## Addendum No. 2

**Project:** 2017 Renovations  
**Manchester Elementary**  
Aurora, Indiana

**Proj. No:** 1649.02

**Date:** November 13, 2017

# Restroom Lintel Plan

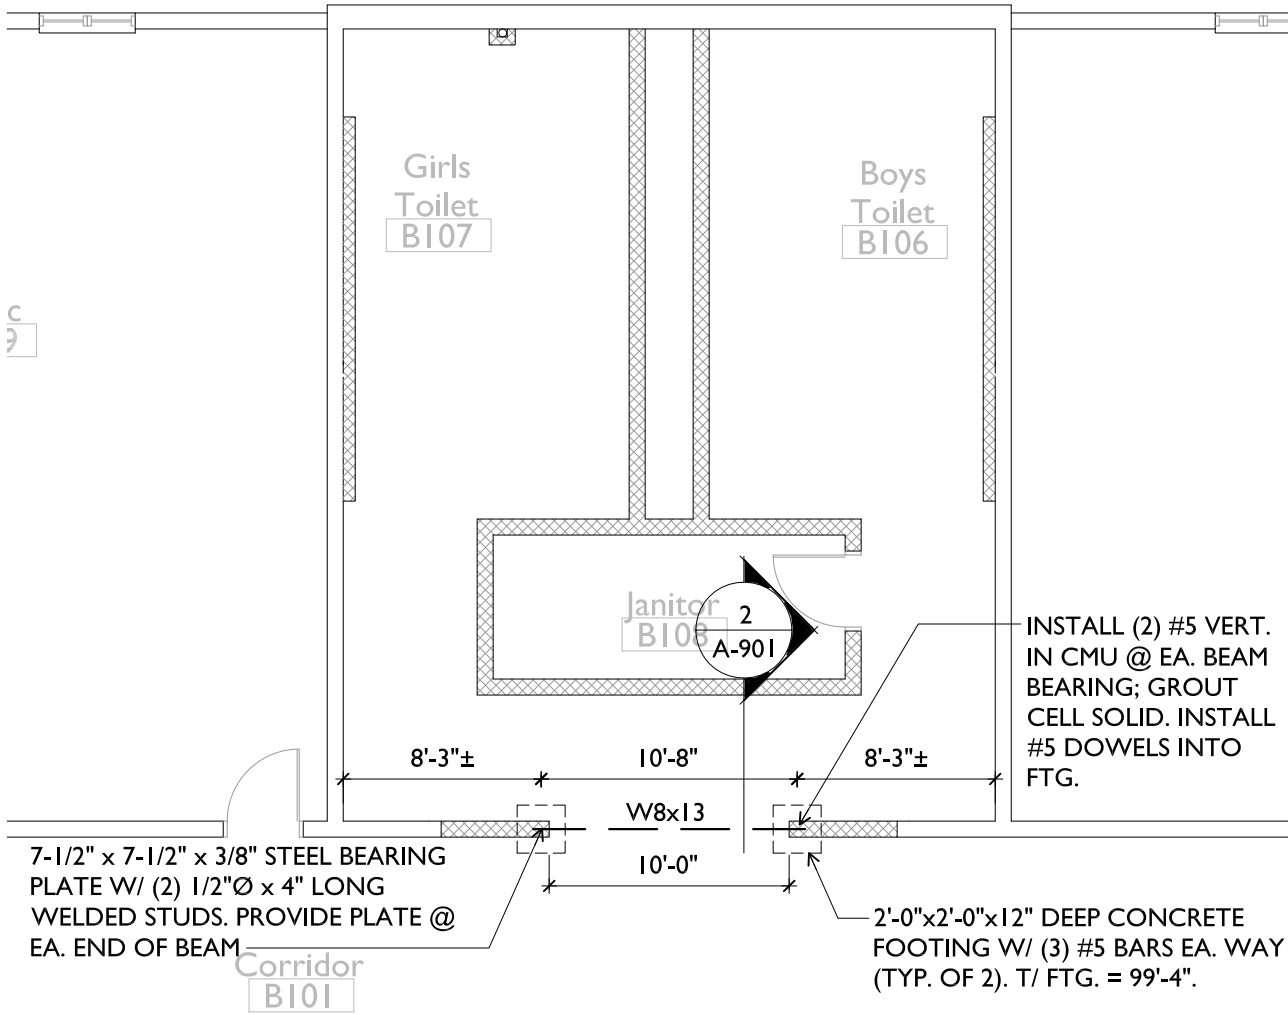
In Corridor B158, Add keynote D31 extending from Science Room 22 across full width of Corridor.
11. Drawing A-101  
Add Restroom Lintel Plan 1/A-101 per attached Drawing AD-2a.

12. Drawing A-102 (Area "B" Architectural Floor Plan)  
Add Plan Keynote A3 in Corridor B101 outside Boys Toilet B106 and Girls Toilet B107. Install new floor slab as required due to installation of new concrete footings. See Restroom Lintel Plan per attached Drawing AD-2a for additional information.

# Revised South Fence Layout Plan

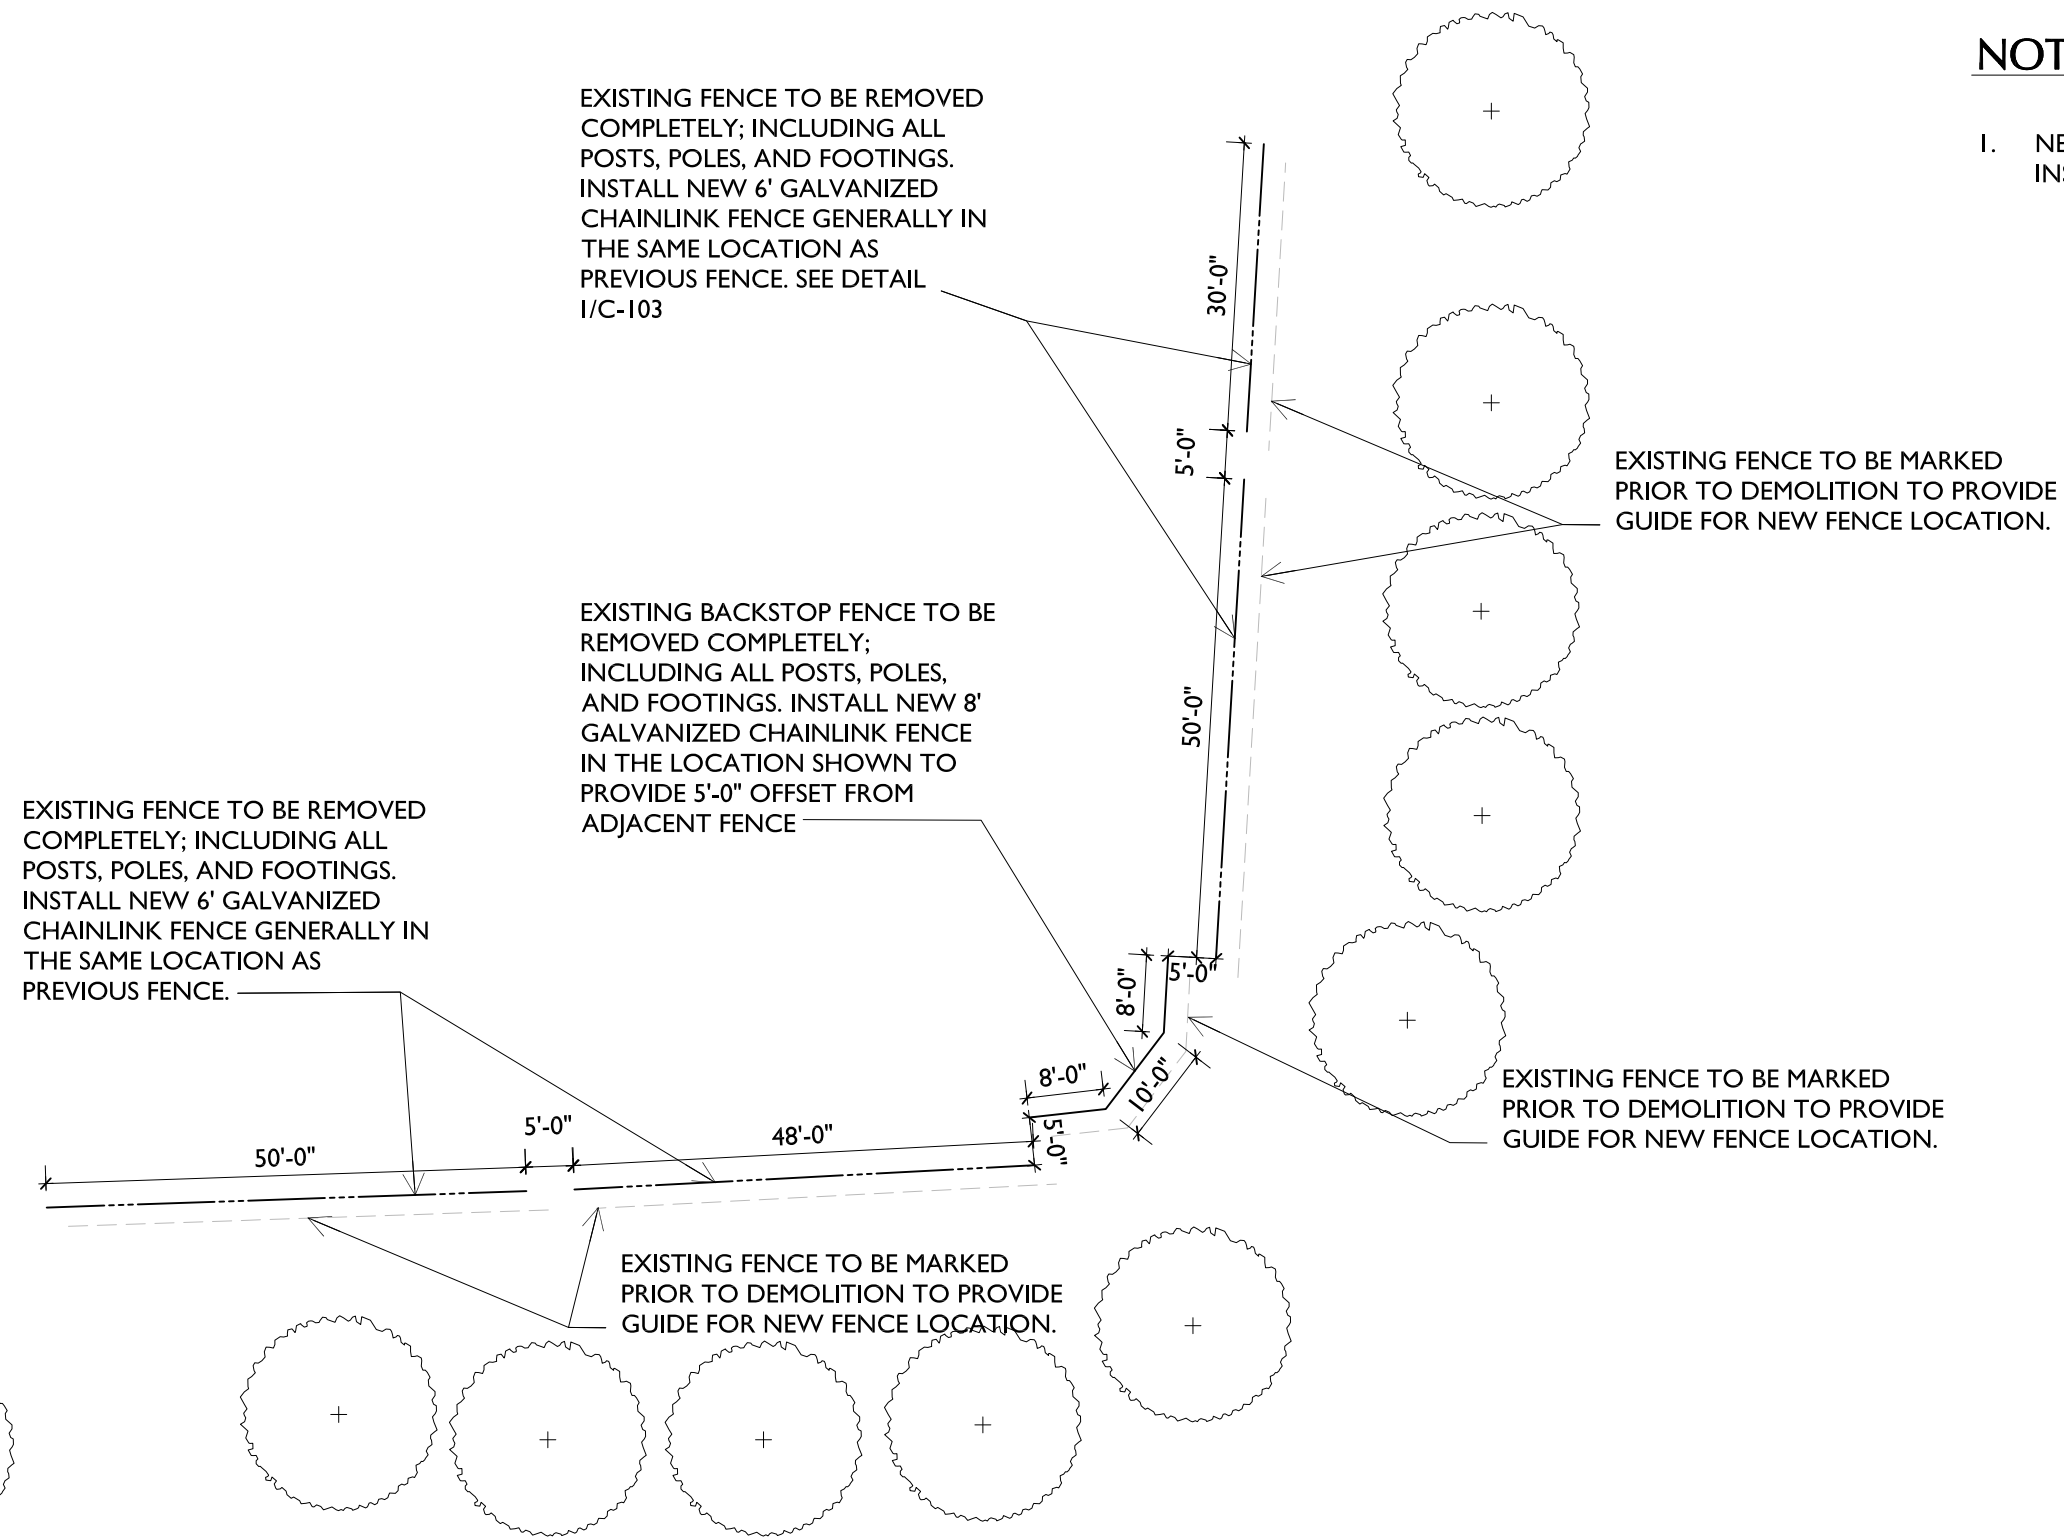
4. Drawing C-103 (South Fence Layout Plan) Plan Adjustments  
Replace the South Fence Layout Plan detail with new layout per attached Drawing AD-2c.
5. Drawing C-104 (Playground Layout Plan) Sidewalk Adjustments  
Revise width of new concrete walk to playground from existing drive from 6'-0" to a total of 10'-0".  
Coordinate walk location with Architect.

Sheet  
**AD-2d**

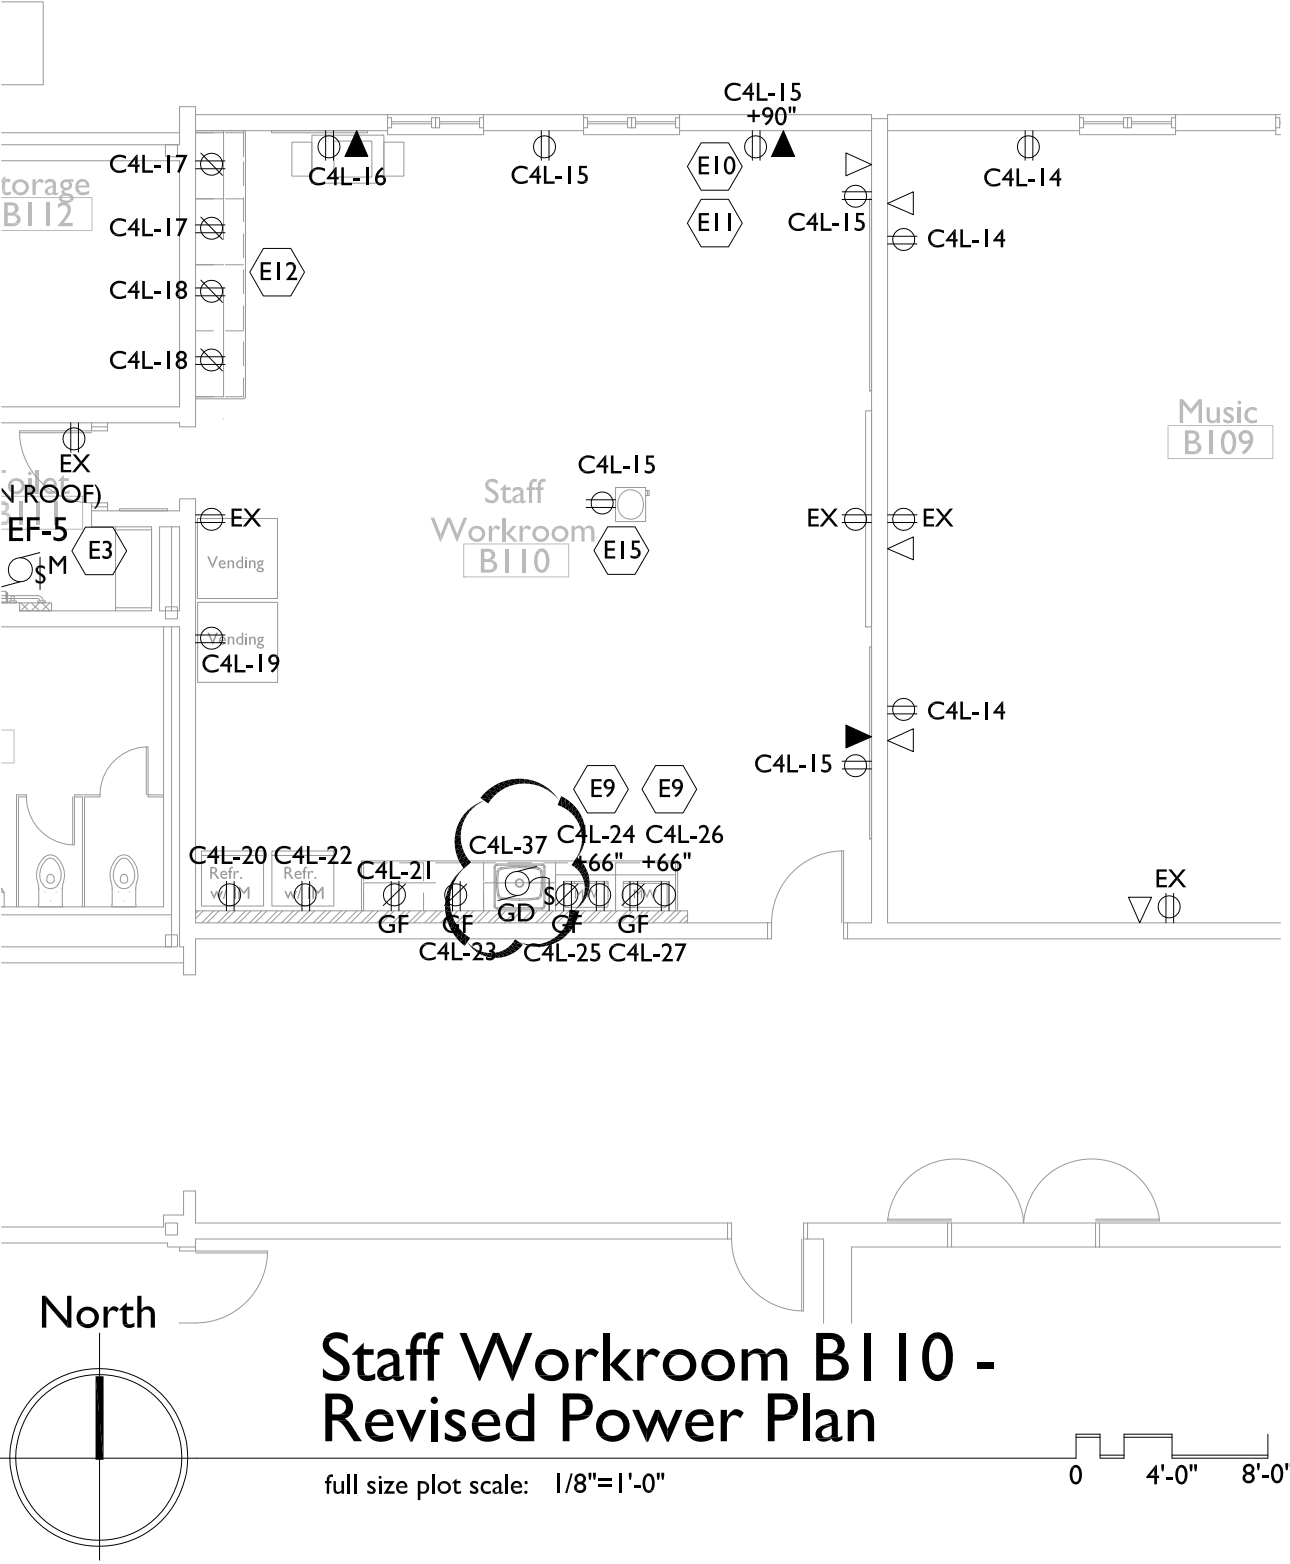
Add power and ON/OFF switch for garbage disposal in Staff Workroom BI 10 per attached Drawing AD-2d.

# Staff Lounge Casework Elevation

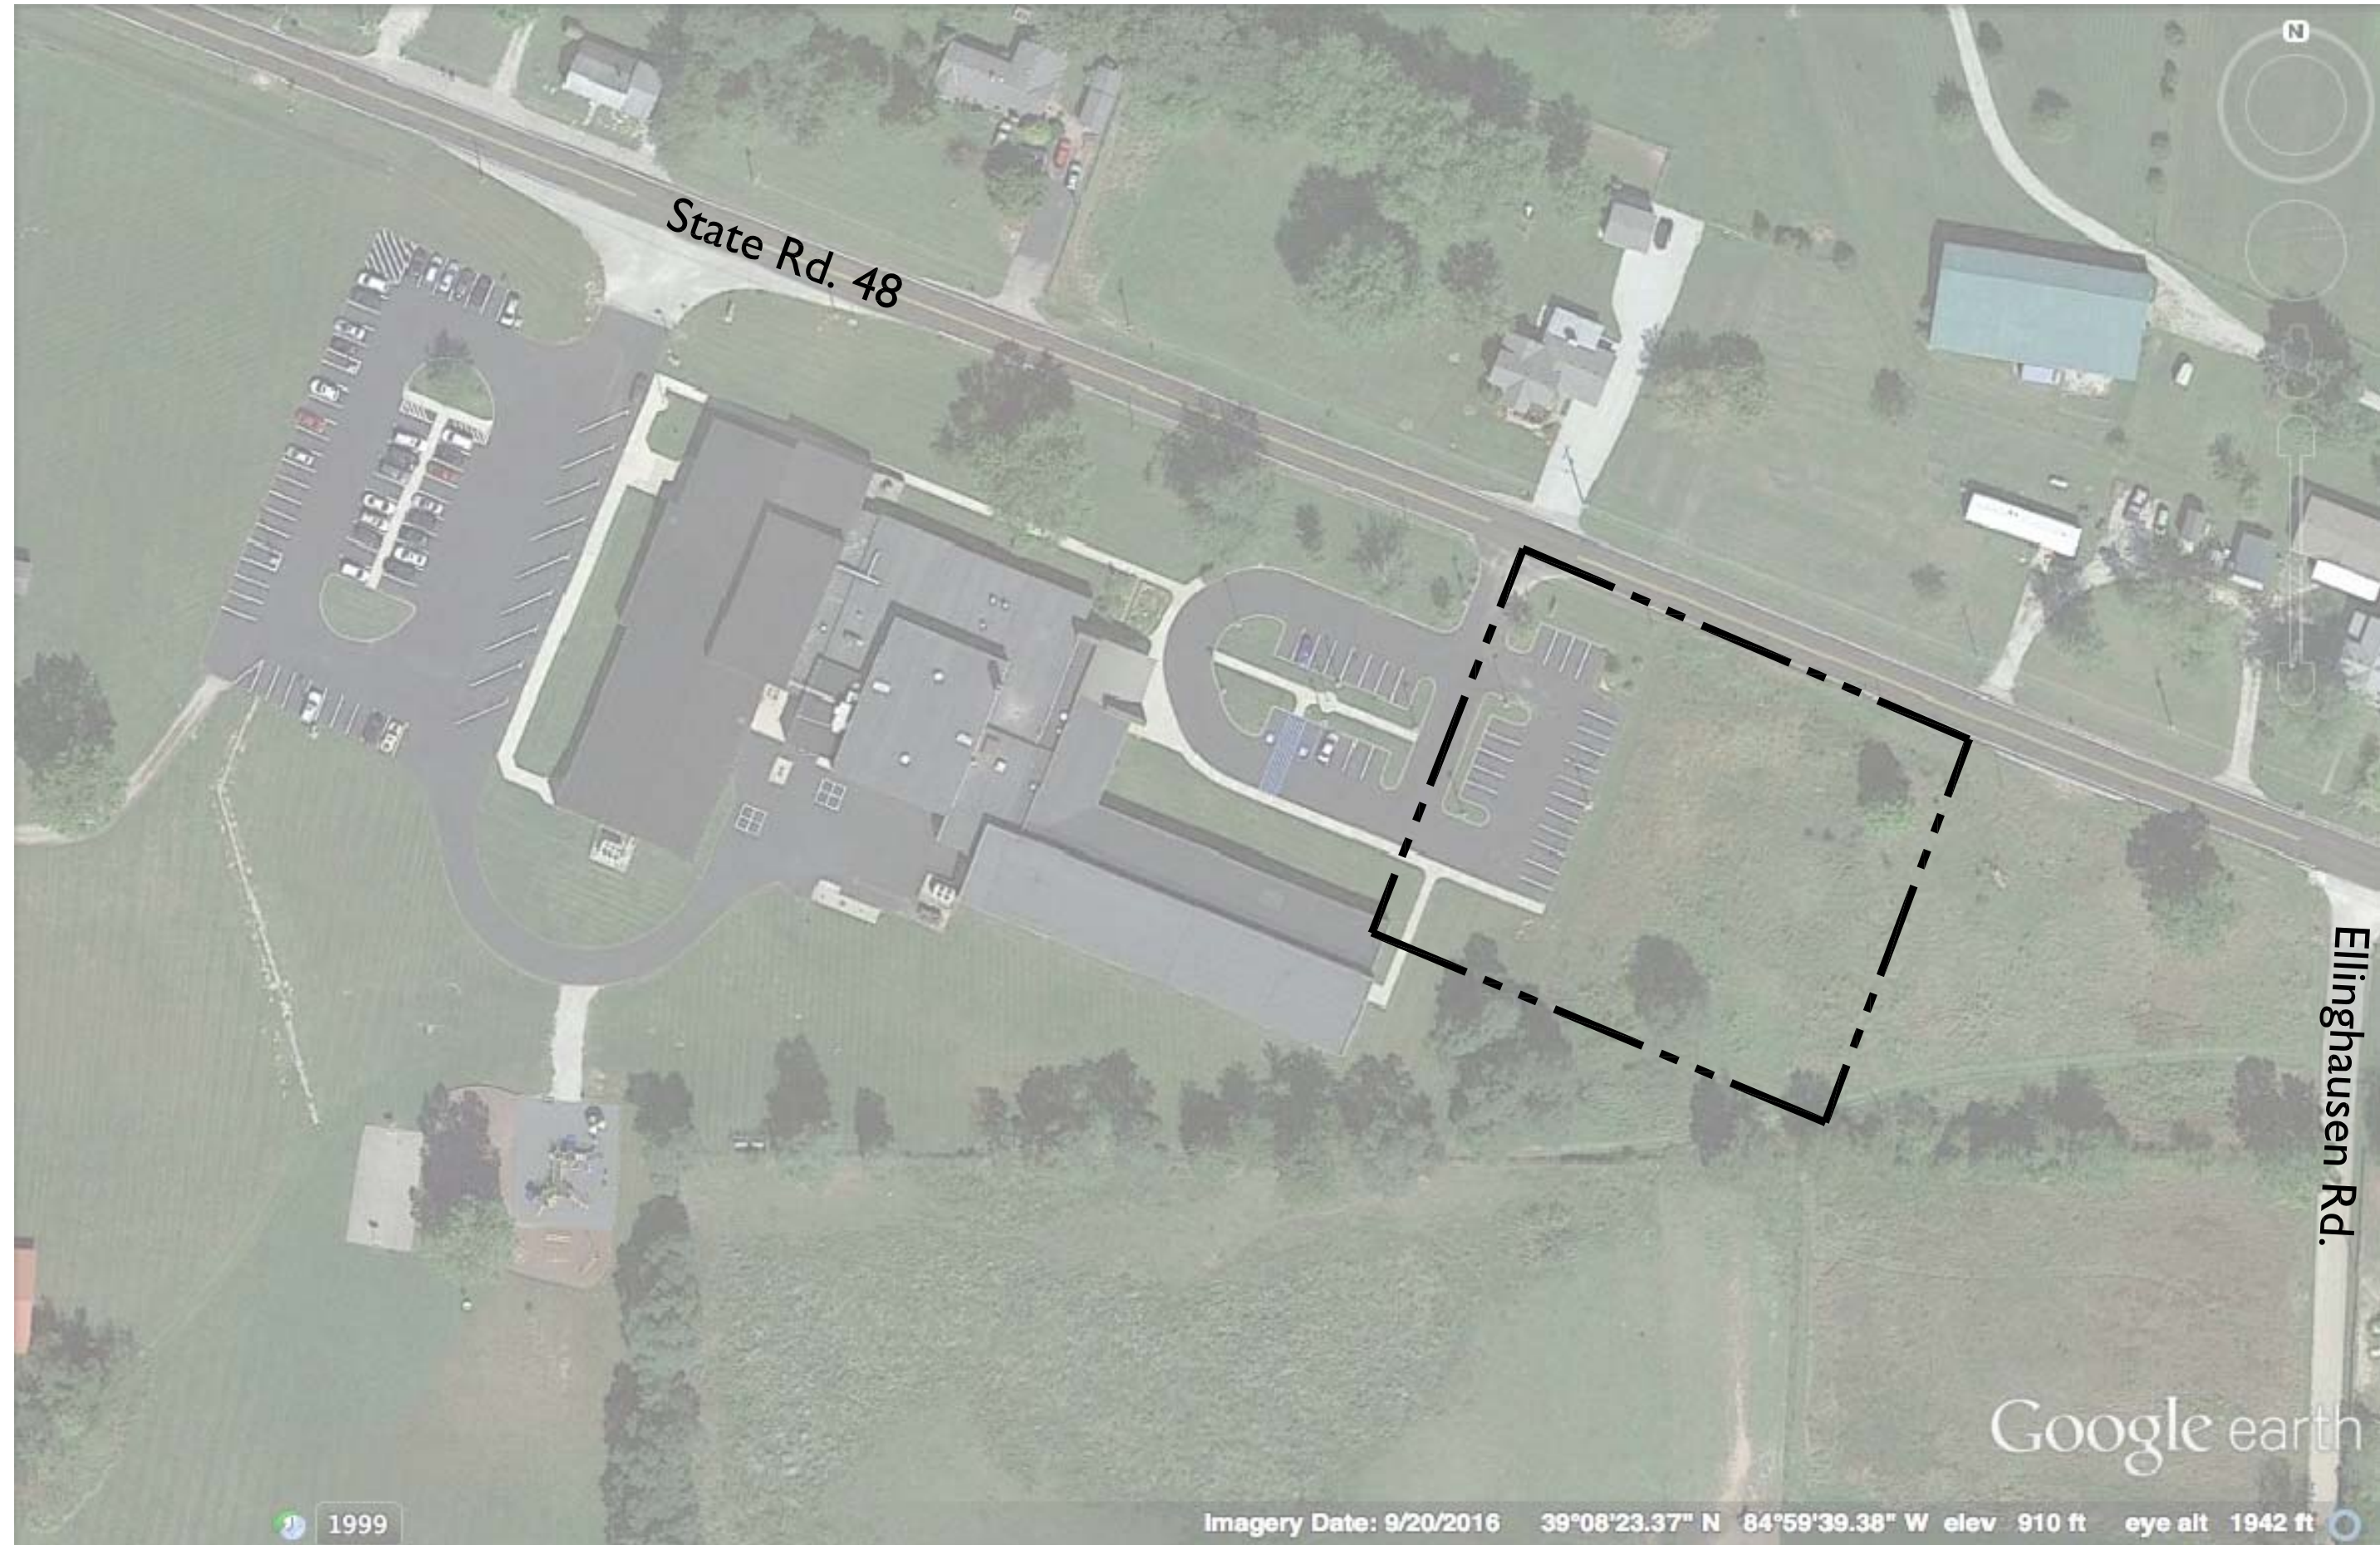
20. Drawing Q-201 (Casework Elevations)  
Elevation 5/Q-201: Change tall cabinet on left to a wardrobe unit. Dimensions and components shall be similar to Wardrobe unit in classrooms.
21. Drawing Q-202 (Casework Elevations)  
Revise Elevation 1/Q-202 per attached Drawing AD-2e.
22. Drawing I-101 (Finish Schedule)  
Wall Finish Keynote PT4: Change paint color to Sherwin Williams 6796 Blue Plate.
